KOWLOON SOUTHERN LINK Contractor's Submission Form

Contract: KDB200 - West Kowloon Station and Tunnels,
Jordan Road to East Tsim Sha Tsui Station

Title of Submission: Environmental Monitoring and Audit Groundwater Monitoring Working Plan

Submission Ref. No. KDB200/CSF/ENV/000152/H

APPENDIX B GROUNDWATER MONITORING LAYOUT PLAN

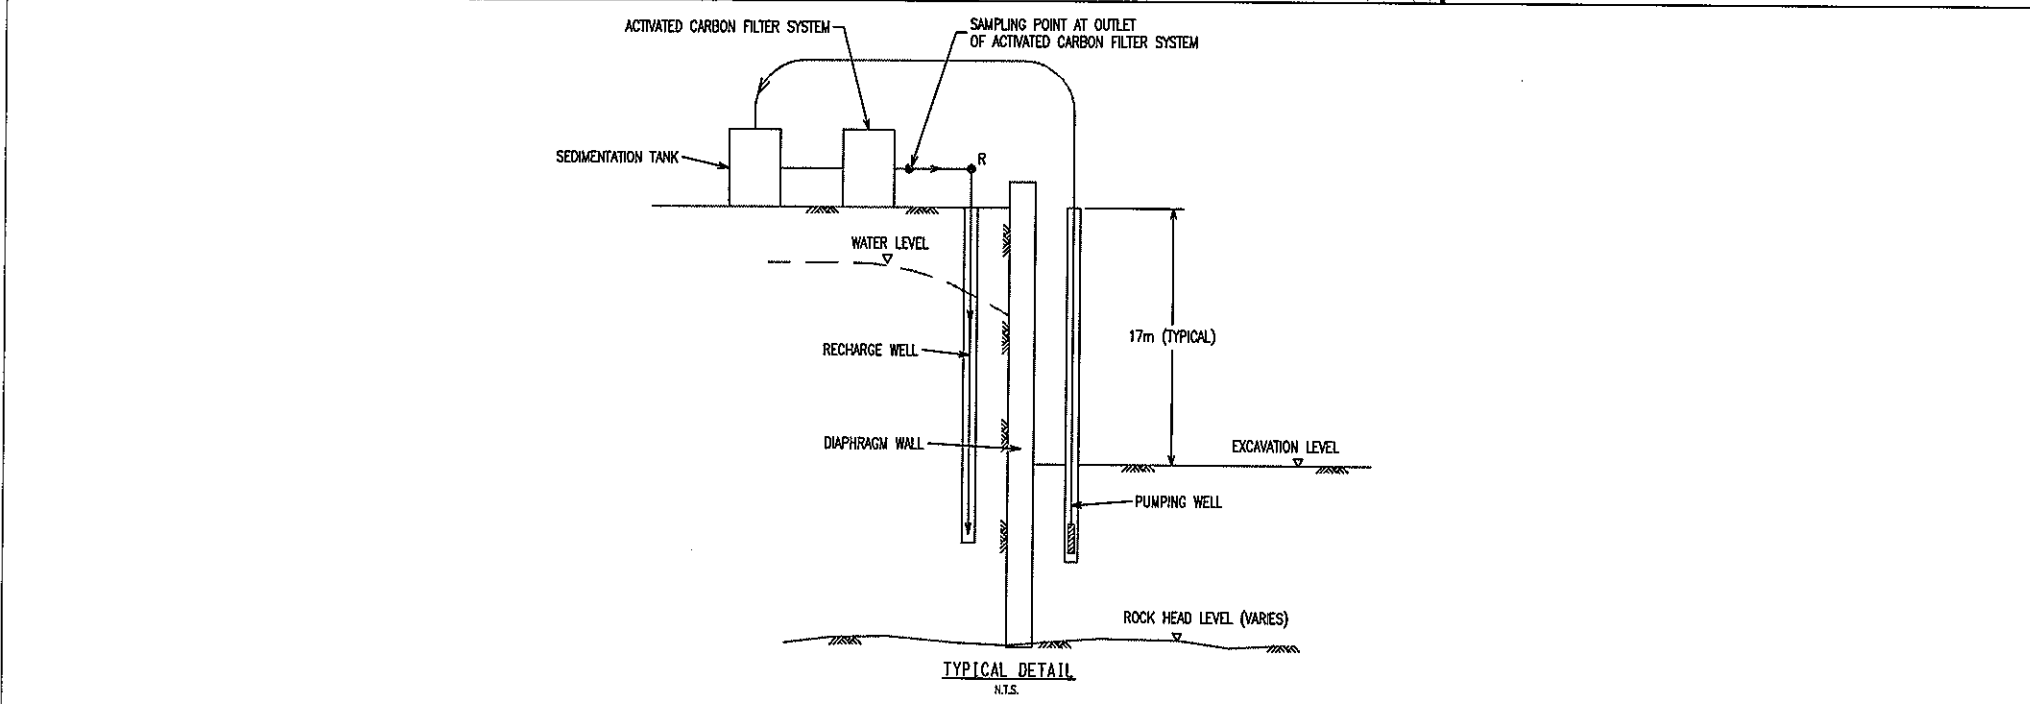
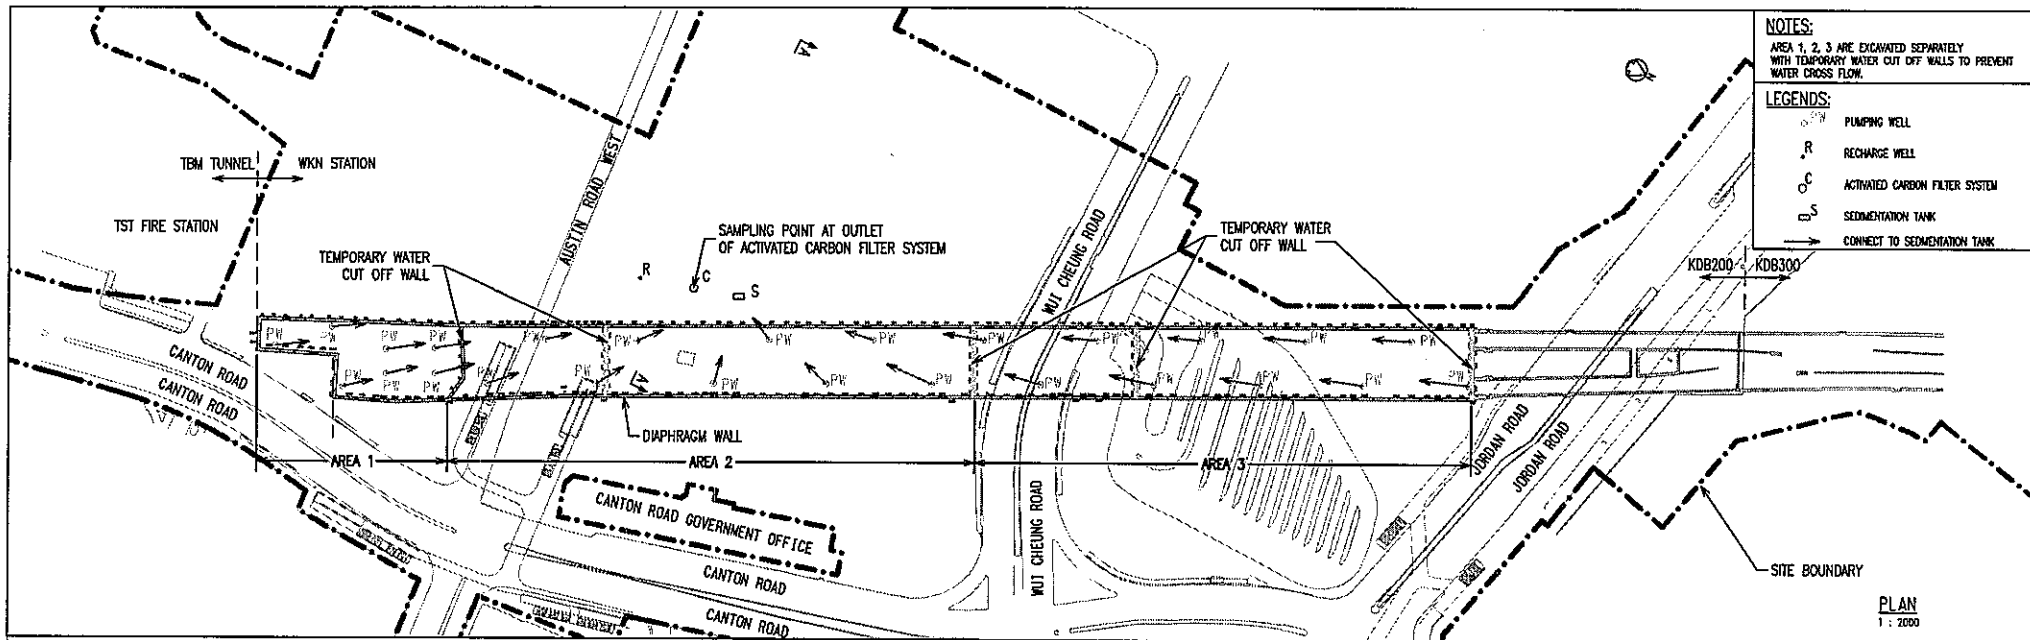
Item	Comments	Responses
ii.	The purpose of point R3 is unclear.	<p>“R3” is originally proposed to be one of the recharge well, similar to other recharge locations R, R1, R2a and R2b. However, after the conducting of baseline monitoring at R3, it was discovered the option of utilizing this recharge well was not viable. R3 will no longer be used for recharging groundwater. The baseline data for R3 is presented in this working plan nevertheless.</p> <p>The relevant text will be revised to reflect the intension of R3.</p>
iii.	The baseline monitoring results of R1, R2a R2b and R3 are dubious. In the results of R2b and R3, there was an extraordinary surge of TPH level in the groundwater of the well on the date of 10.8.06 and there was an aftereffect on 11.8.06. In results of R1 and R2a, the TPH levels in the groundwater was in an odd decreasing trend, as if some contaminants has got into the well right before the baseline monitoring. This odd increase of the range of baseline data will give an unreasonable high action level (which would be set at the 95 percentile of baseline data). KCRC should provide an explanation to these data.	The methodology of the groundwater sampling, as stated in Section 3.3 of the Groundwater Monitoring Working Plan, was properly followed by LJV during the baseline monitoring. Analyses were undertaken by a HOKLAS accredited laboratory. Consideration had been given to the natural fluctuation of the groundwater system. Thus, the baseline data were reliable.

After the conducting of baseline monitoring at R3, it was discovered the option of utilizing this recharge well was not viable. The baseline data for R3 is presented in this working plan nevertheless.
